63-71 WATERLOO ROAD MACQUARIE PARK

AMENDED PLANS

A21005 09/12/21

Drawing Title		Project No.	
SITE ANALYSIS		A21005	
SCALE	Date	Drawing no:	ISSUE
1 : 250 @ A1	2021.10.29	A2.01	C

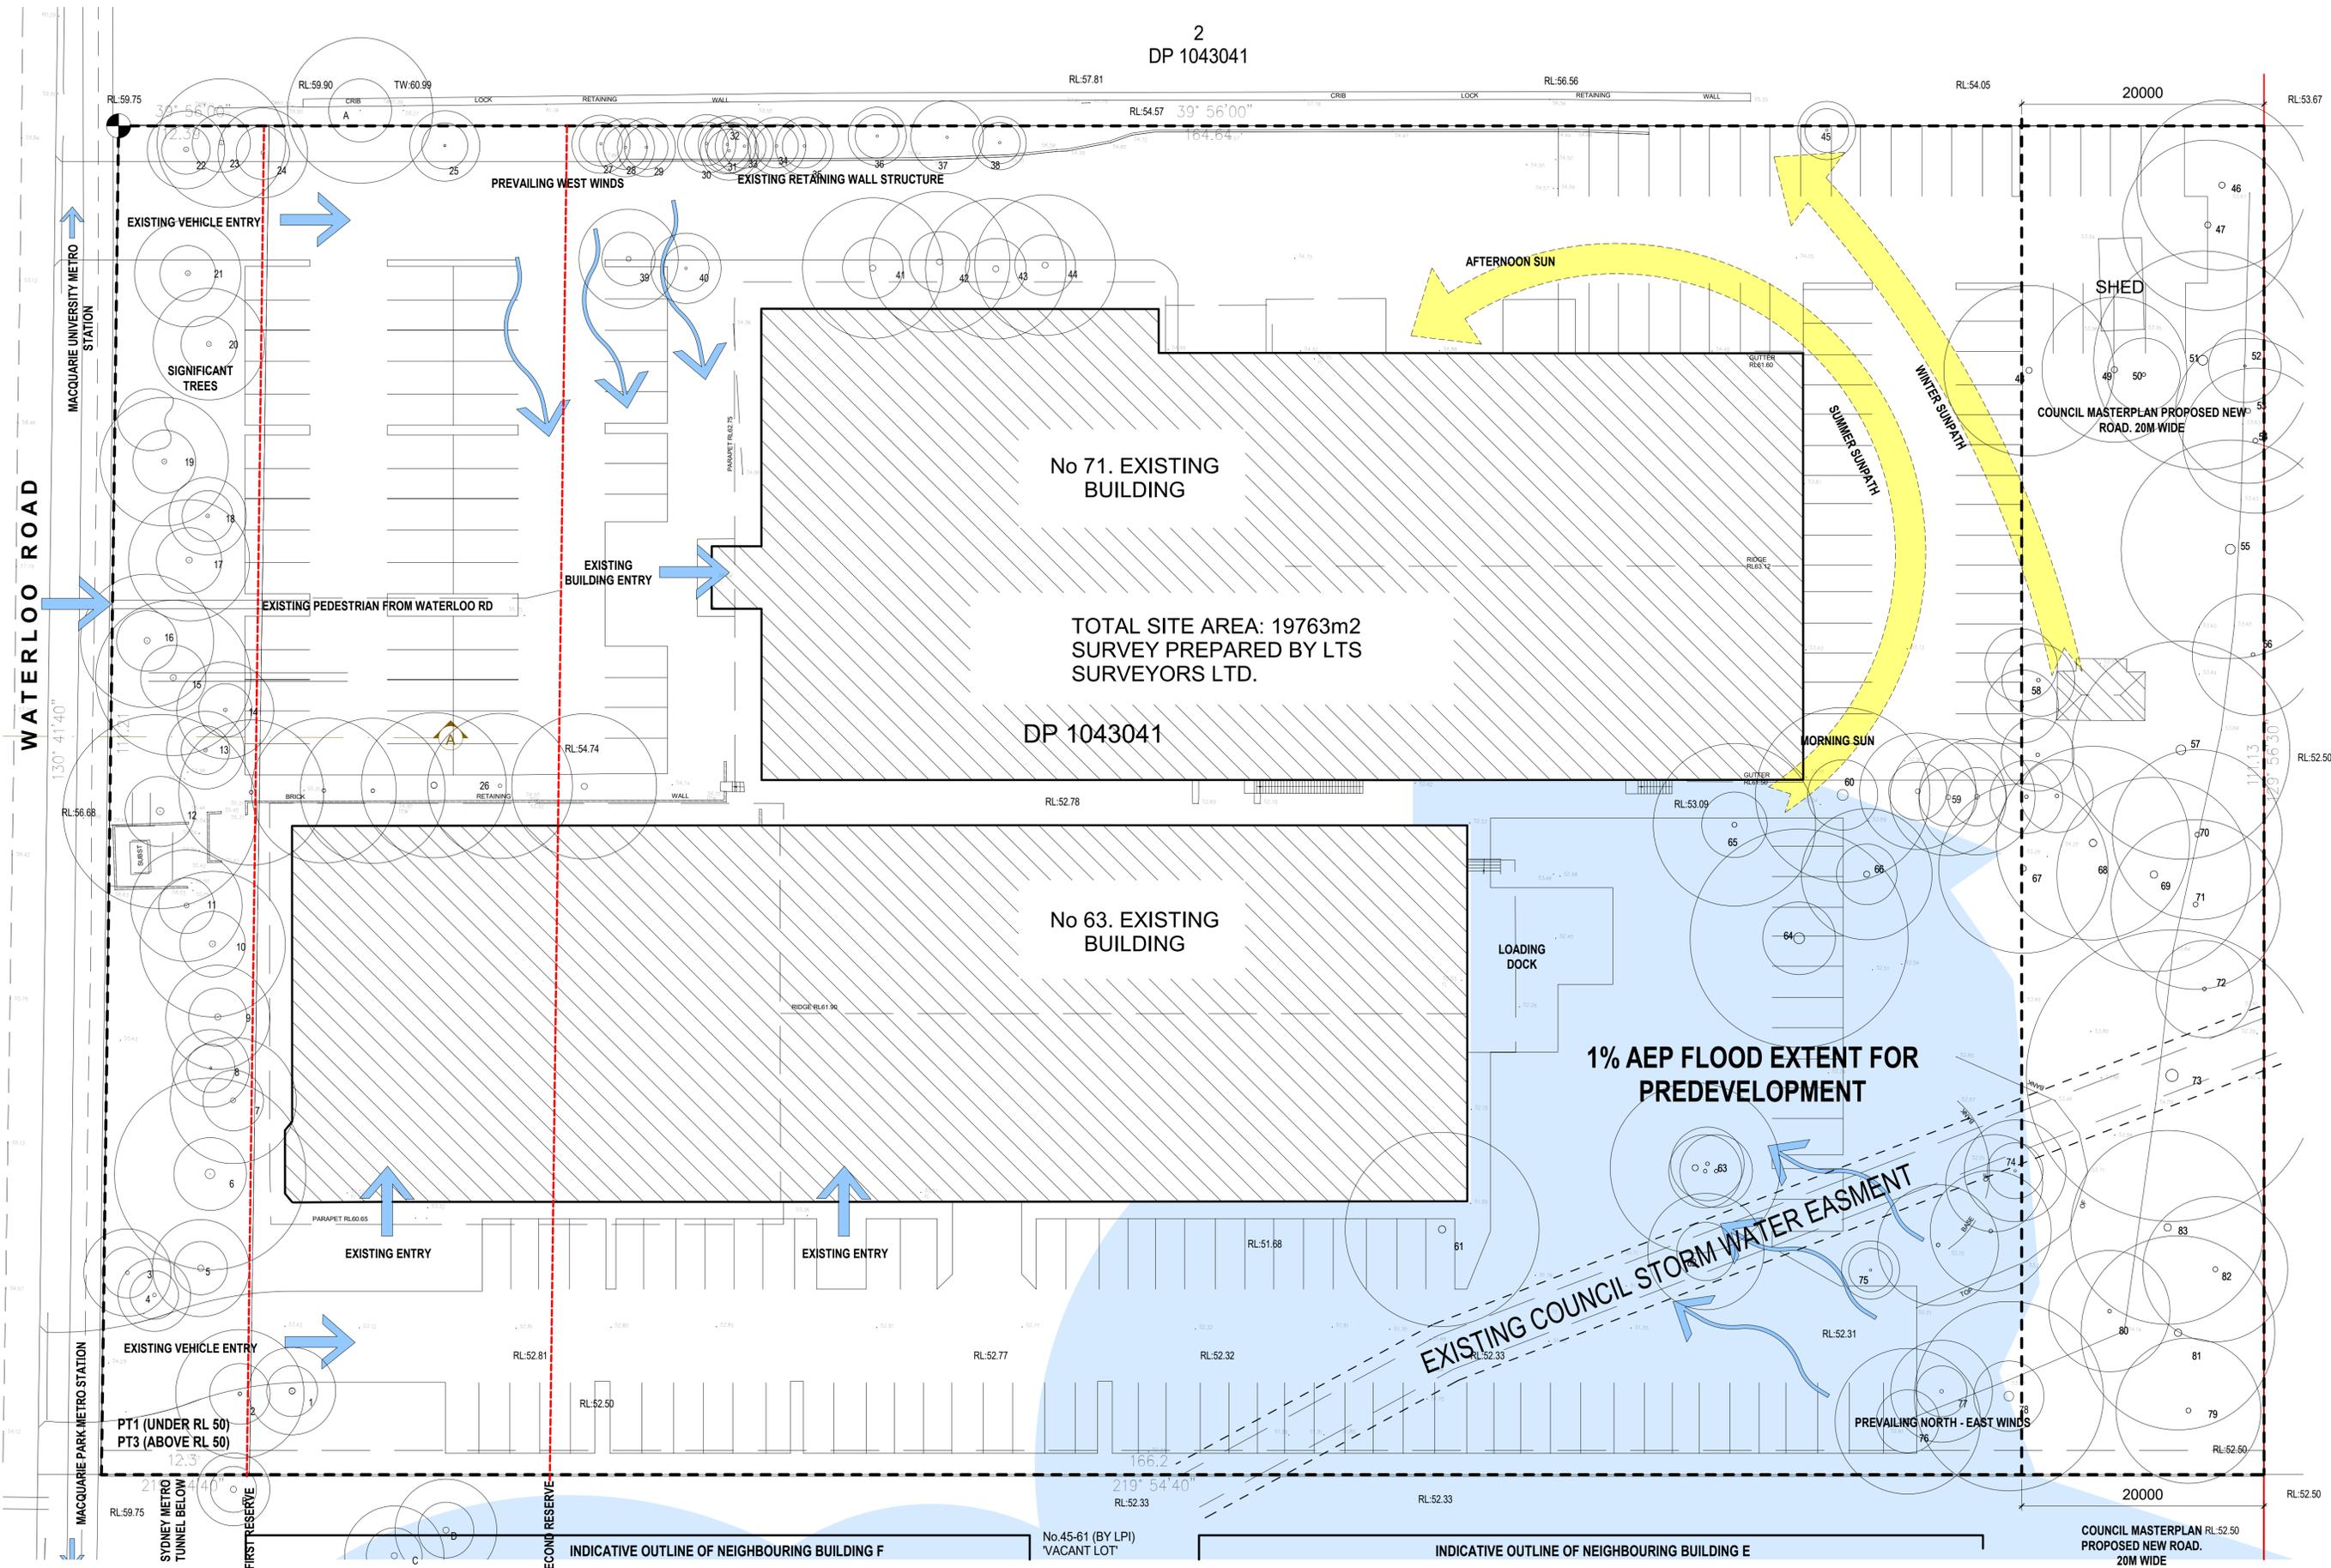
1. **Vehicular Access & Parking** – Extension of existing driveway and verge condition to create Private Road along western boundary to connect with Road 1. Relocation of basement access off private road.

2. **Waterloo Road Interface / Response** – Buildings setback from Sydney Metro 1st Reserve and Entry Plaza to enhance visual response from Waterloo Road. This is further enhanced by retail areas at the double height lobby; Basement adjusted to be clear of Sydney Metro 2nd Reserve.

3. **Staging** – Staging revised to be 2 phases only. Stage 1: Road One, Stage Two: Remaining Works.
4. **DDA Accessibility** – DDA compliant ramp added alongside the stairs in the 'central spine'; Accessible pathway added to reach entrances; Accessible car spaces relocated adjacent to lift cores.

5. **Road 1 Design Levels and Overland Flow Crossing** – Culvert under Road 1 for lower flows. Safety screens over culvert entry points.
6. **Landscape / Trees / Amenity Shading** – Building replanned at upper levels to provide covered walkway over the 'central spine' for weather protection; Depth of deep soil areas shown on sections to demonstrate compliance; Communal Open Space areas within north-western portions of the site providing min. of 3 hours of winter sun. New pad mounted kiosk relocated for ease of access for maintenance. Enhancement of existing driveway and verge condition to create Private Road design to provide retention of Trees 39-44.

7. **Retail Uses** – Sections and plans revised to clarify retail location. Upper ground floor retail orientated to promote activation to the Waterloo Road frontage; Provision of direct street access into both Building A and B retail tenancies via sliding doors.

8. **ESD** – Solar façade louvres added; Development commits to achieving 4 Star Green Star rating to comply with DCP.
9. **Deep Soil** – 'Central Spine' sections updated to demonstrate deep soil compliance with additional deep soil landscape provided at the North/West edge. Total deep soil landscape is over min. 20% DCP requirement.

10. **End of Trip Facilities** – Bicycle spaces and EOT facilities located on Basement 1 with direct access to lift and stairs.
11. **Sydney Metro Reserve** – 1st and 2nd Reserve boundaries shown on sections and plans. Basement footprint setback from the 2nd Reserve.

12. **Architectural Detail** – Additional 3D façade sections added to documentation set to illustrate building façade articulation, materiality, and ESD strategy; Additional dimensions and information added, shadow diagrams updated.

13. **Development Summary** - GFA maintained at 59,289sqm and height below the height plane.
14. **Building A** - 2 storey colonnade added to the north and east of Building A.

18. **Substation** - Relocation of originally proposed substation kiosk to be within Building B.
19. **Tanked Basement** – New tanked basement shoring detail provided.

Drawing Title		Project No.	
DEMOLITION PLAN		A21005	
SCALE	Date	Drawing no:	ISSUE
1 : 250 @ A1	2021.10.29	A2.03	C

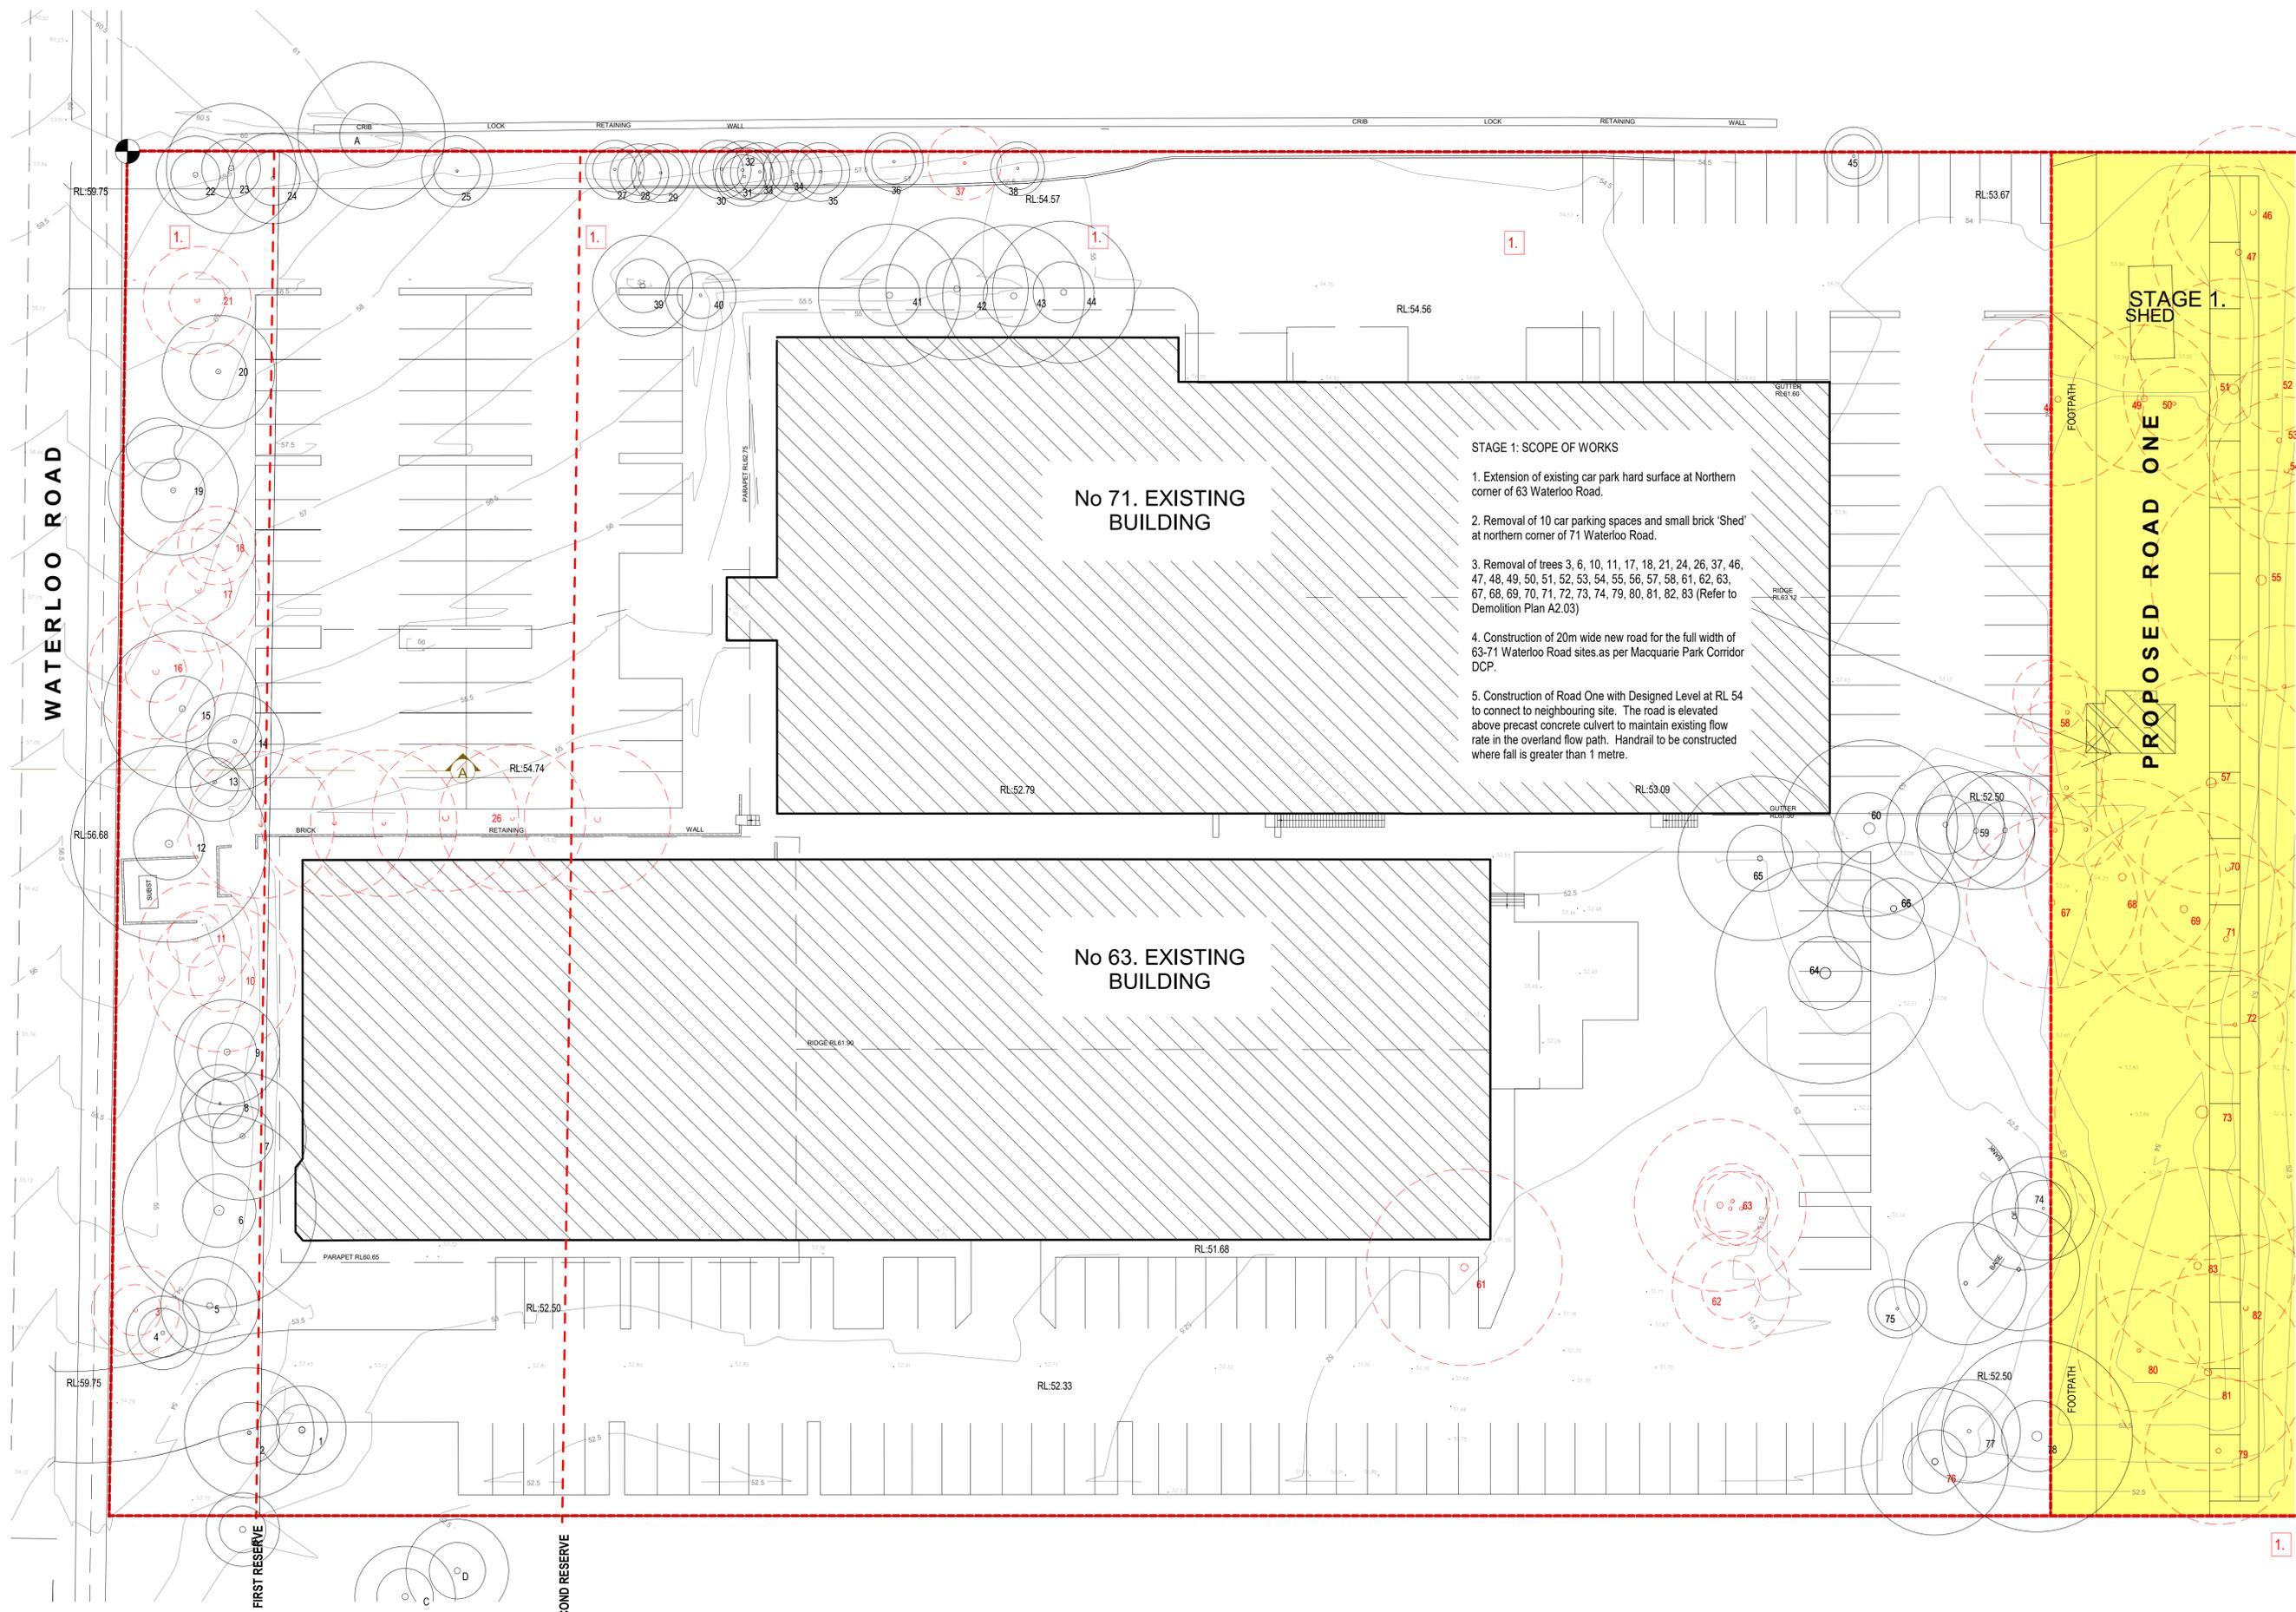
1. Extension of existing car park hard surface at Northern corner of 63 Waterloo Road.
2. Removal of 10 car parking spaces and small brick 'Shed' at northern corner of 71 Waterloo Road.
3. Removal of trees 3, 6, 10, 11, 17, 18, 21, 24, 26, 37, 46, 47, 48, 49, 50, 51, 52, 53, 54, 55, 56, 57, 58, 61, 62, 63, 67, 68, 69, 70, 71, 72, 73, 74, 79, 80, 81, 82, 83 (Refer to Demolition Plan A2.03)
4. Construction of 20m wide new road for the full width of 63-71 Waterloo Road sites as per Macquarie Park Corridor DCP.
5. Construction of Road One with Designed Level at RL 54 to connect to neighbouring site. The road is elevated above precast concrete culvert to maintain existing flow rate in the overland flow path. Handrail to be constructed where fall is greater than 1 metre.
